SUBJECT: Addendum No. 1

PROJECT NAME: Power and Data Cabling Installation for Phase II Surveillance Cameras & Phase I Keyless Entry

JJC PROJECT NO.: B10021

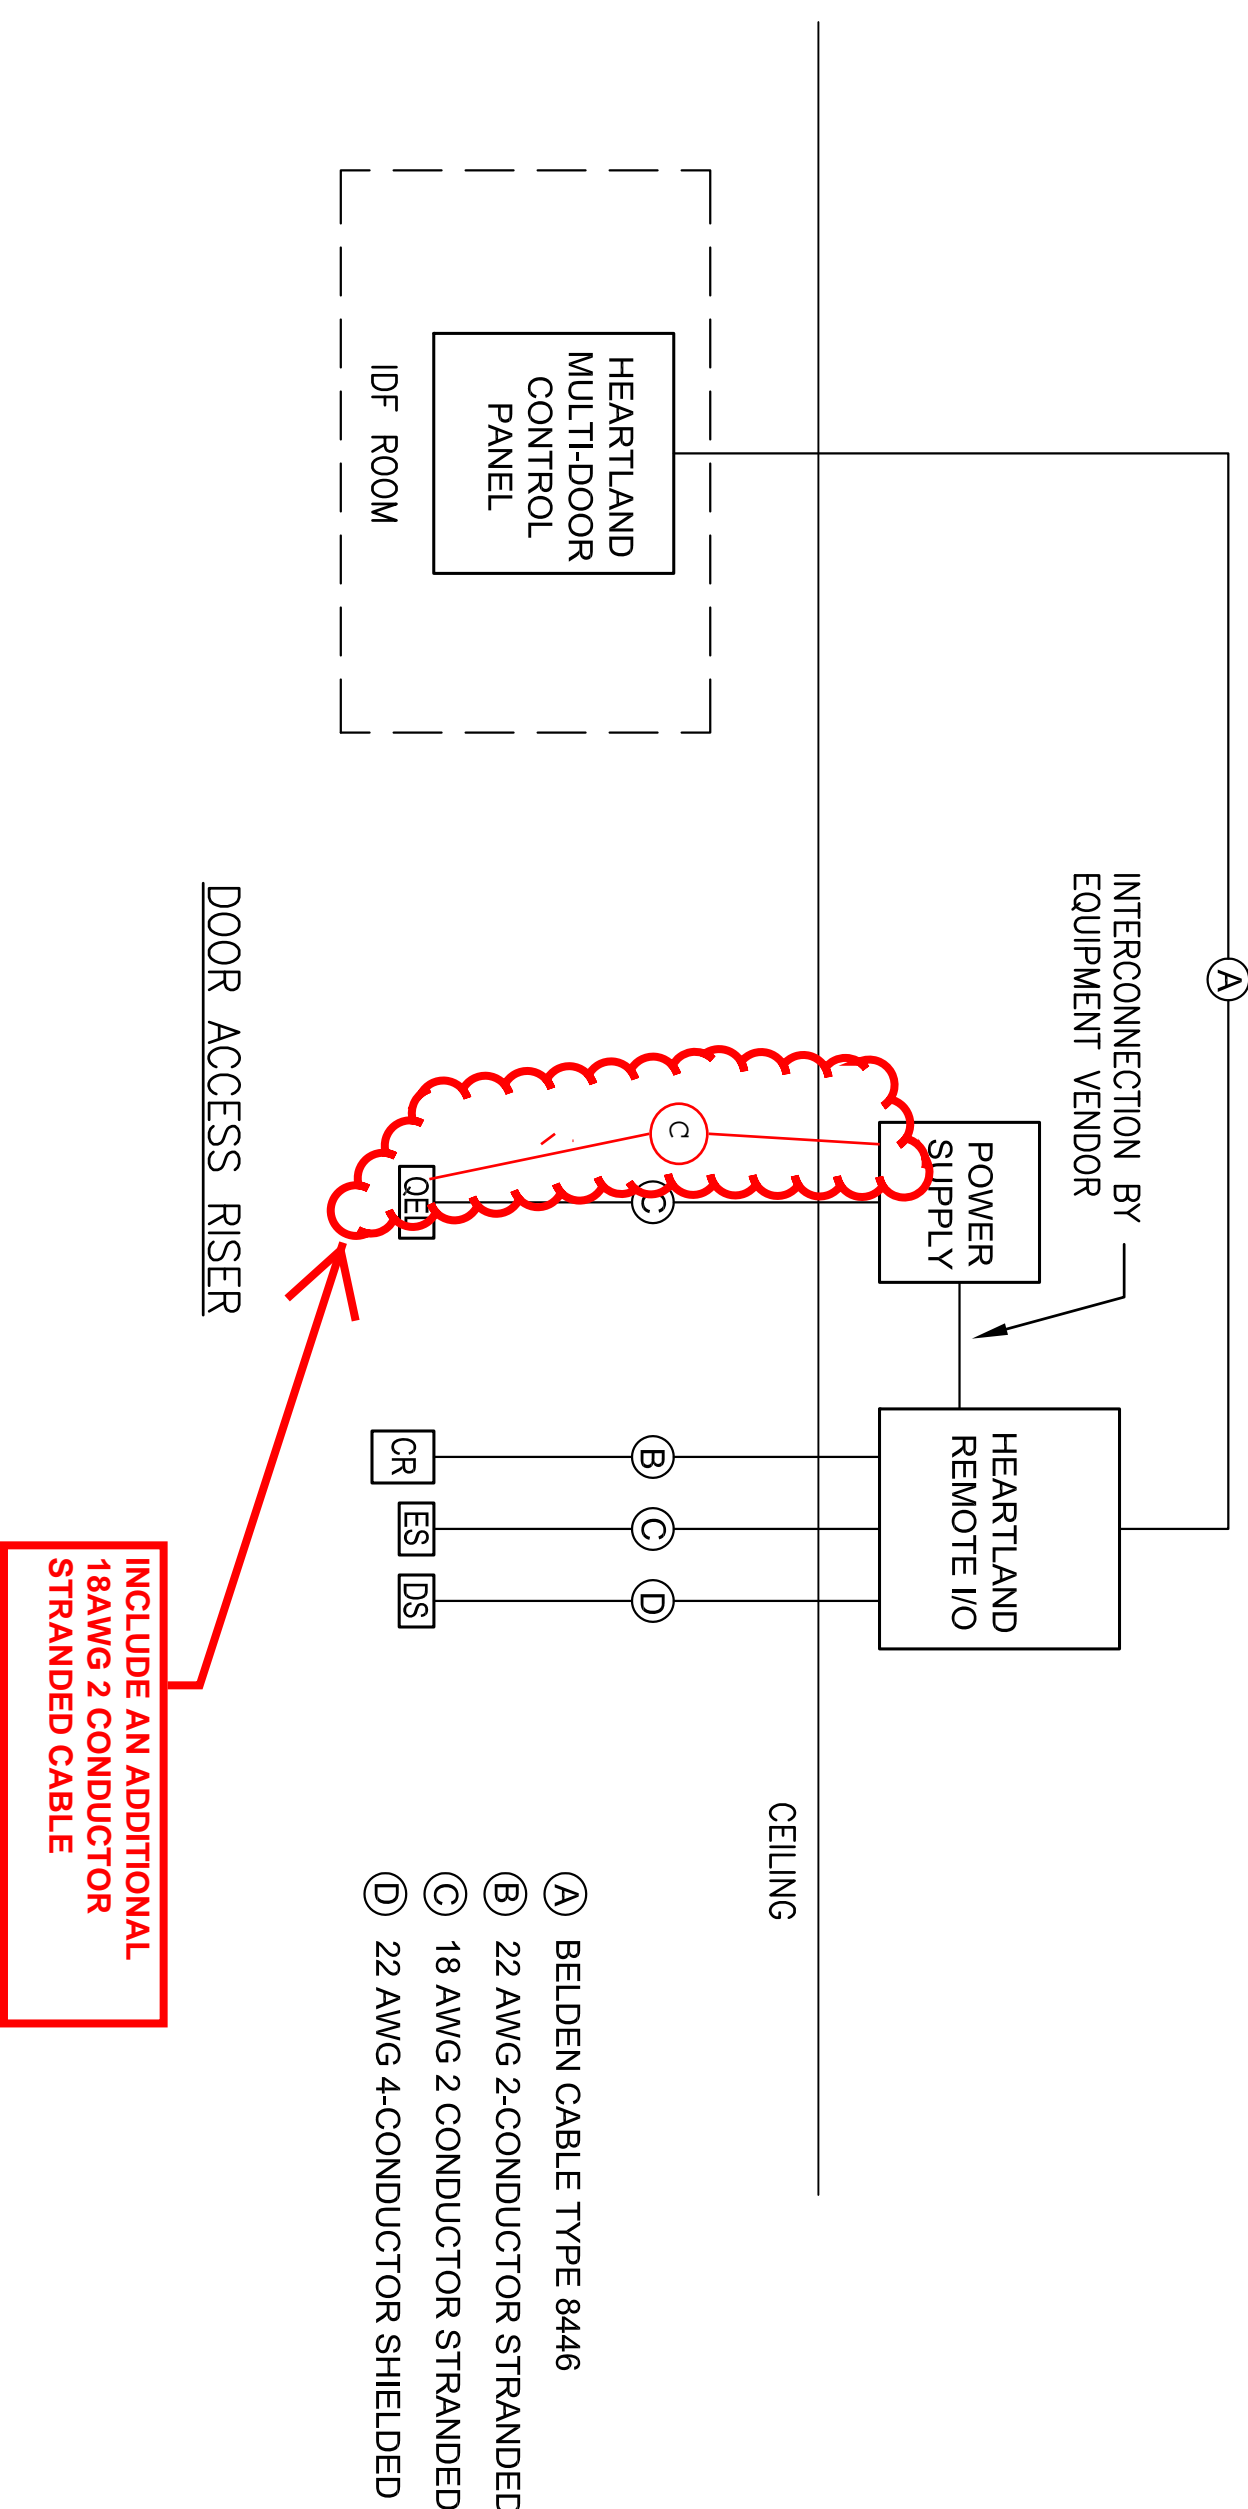
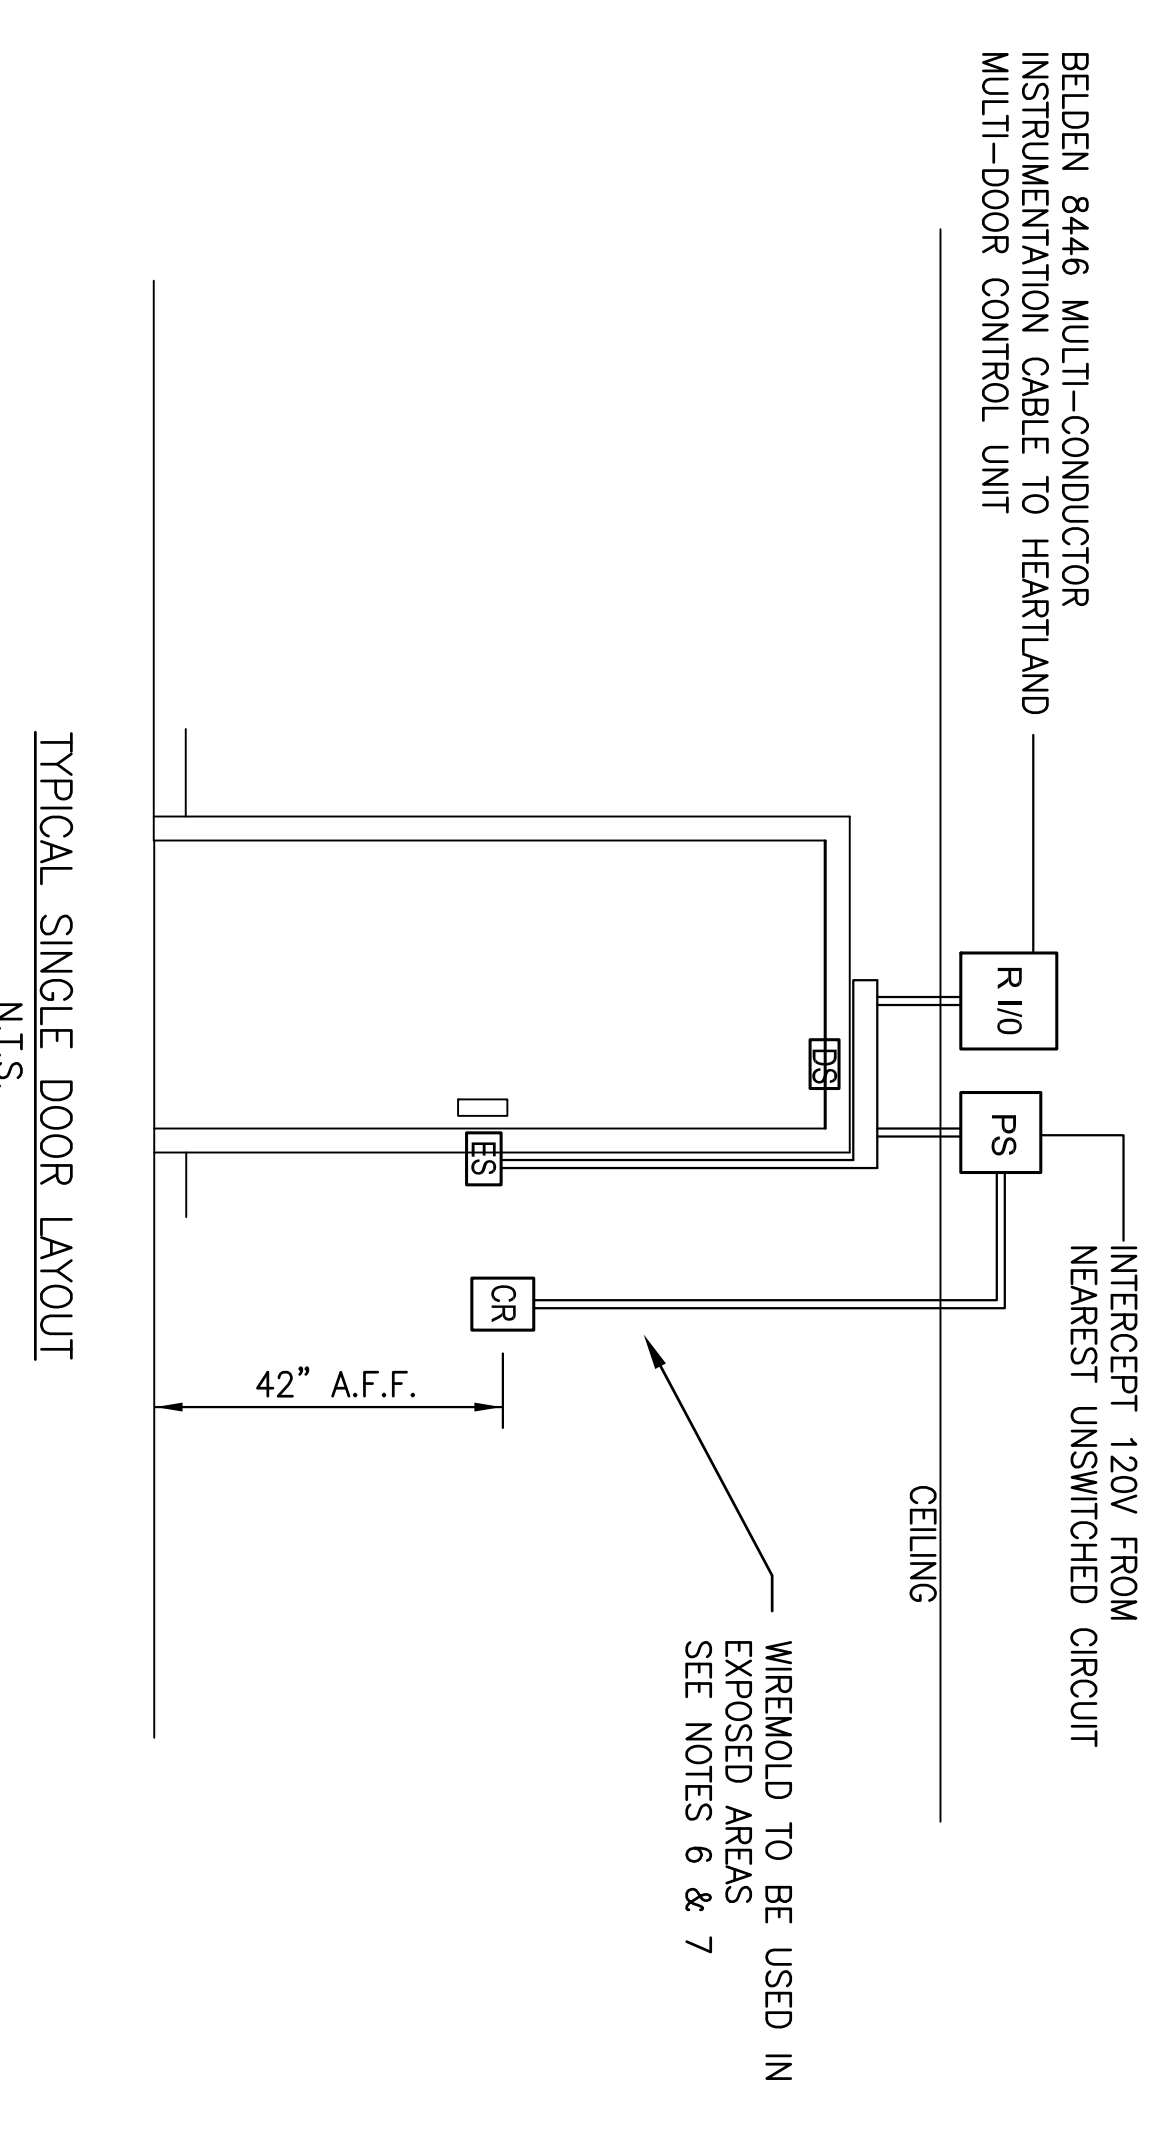
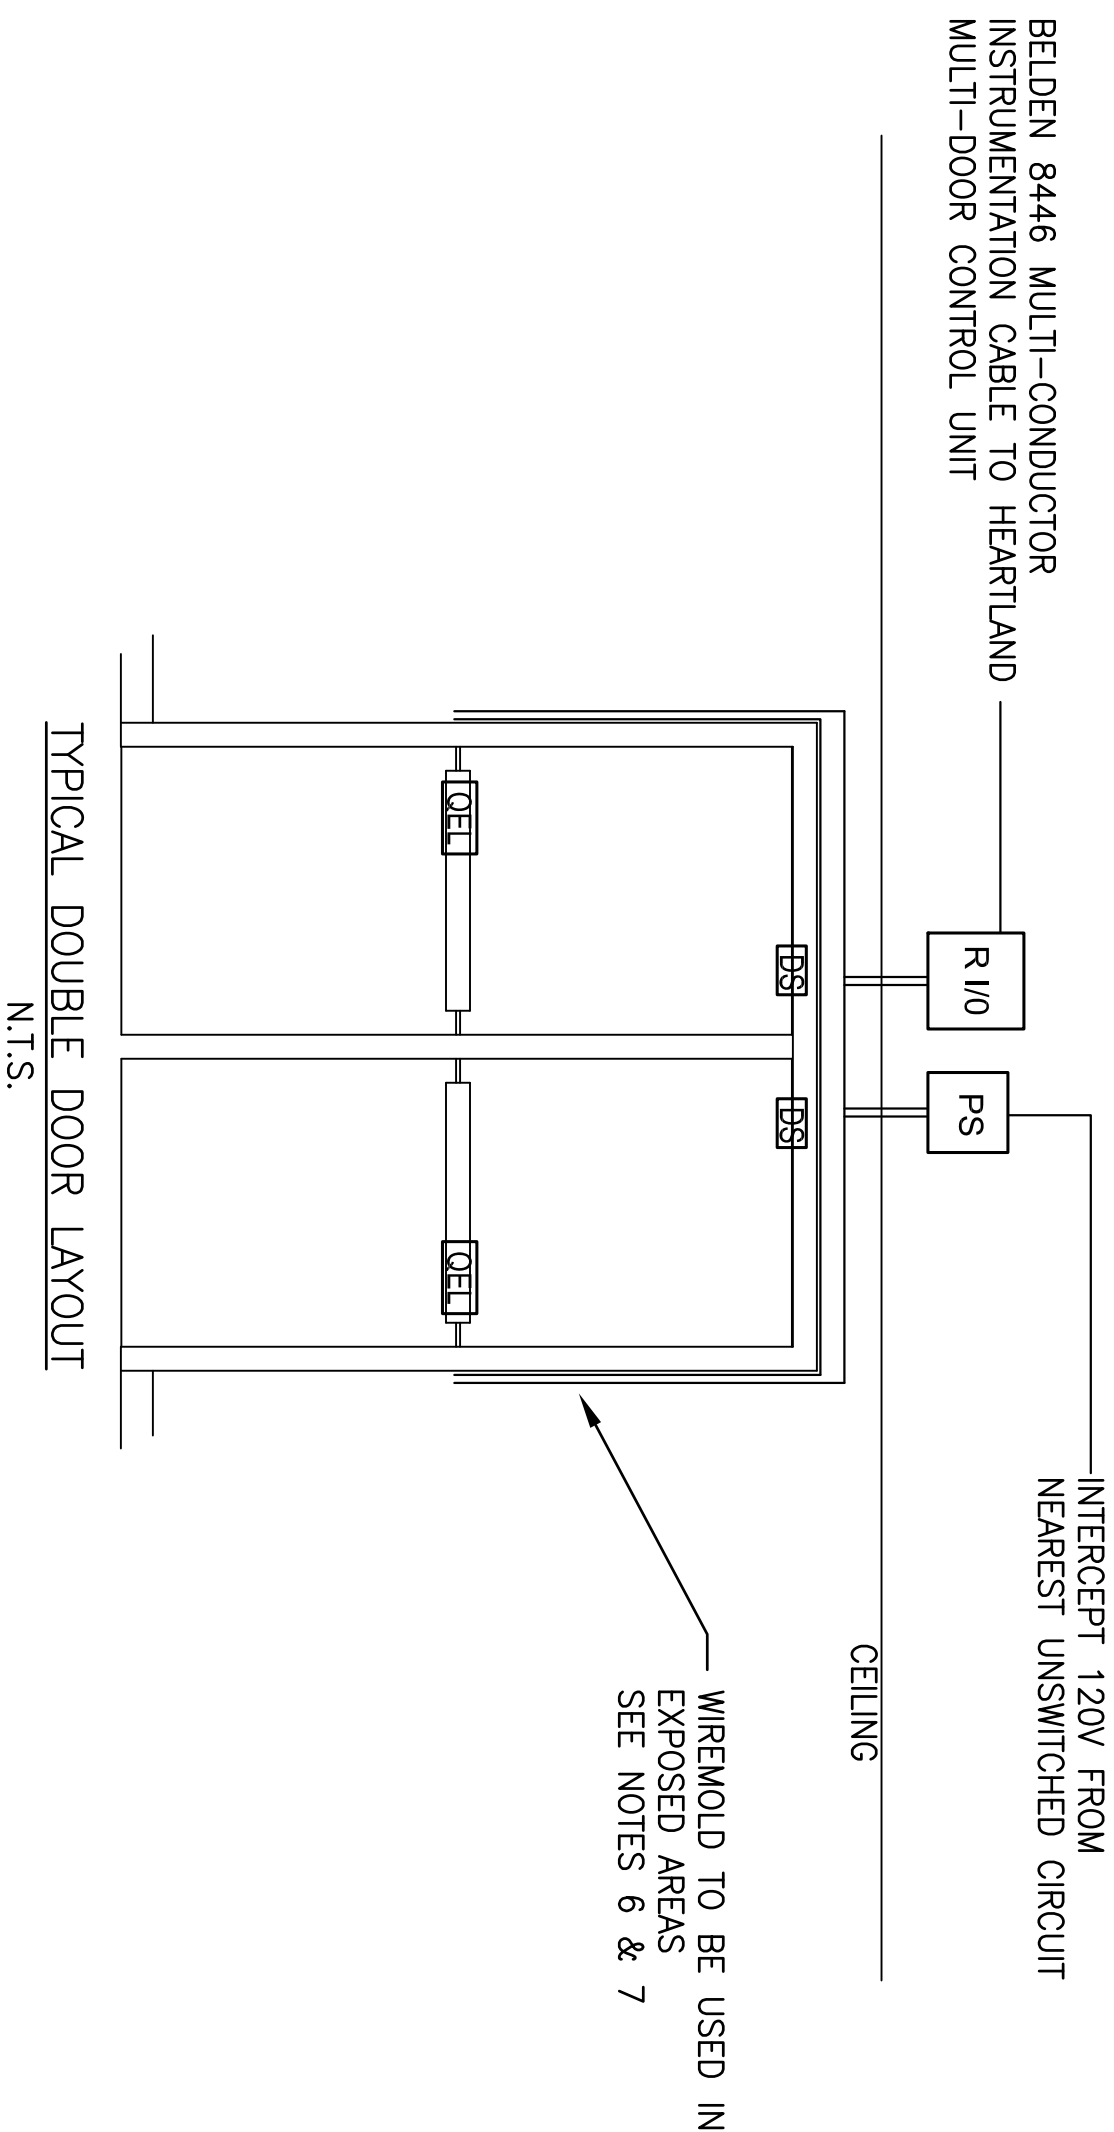
What does the Circle Symbol “CB” on the Parking Lot Camera Pole stand for?

CB means “Emergency Call Box”

ELECTRICAL INSTALLATION DETAILS

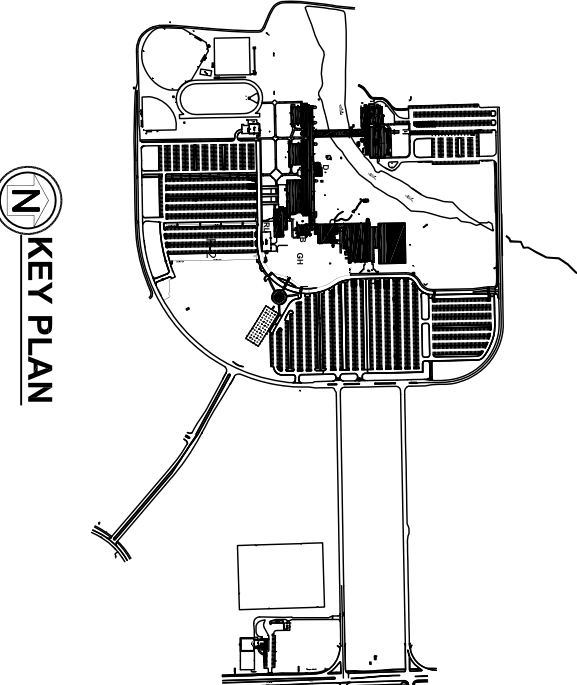
Refer to attached marked-up of door access riser detail on drawing E-D-04 for additional requirements.
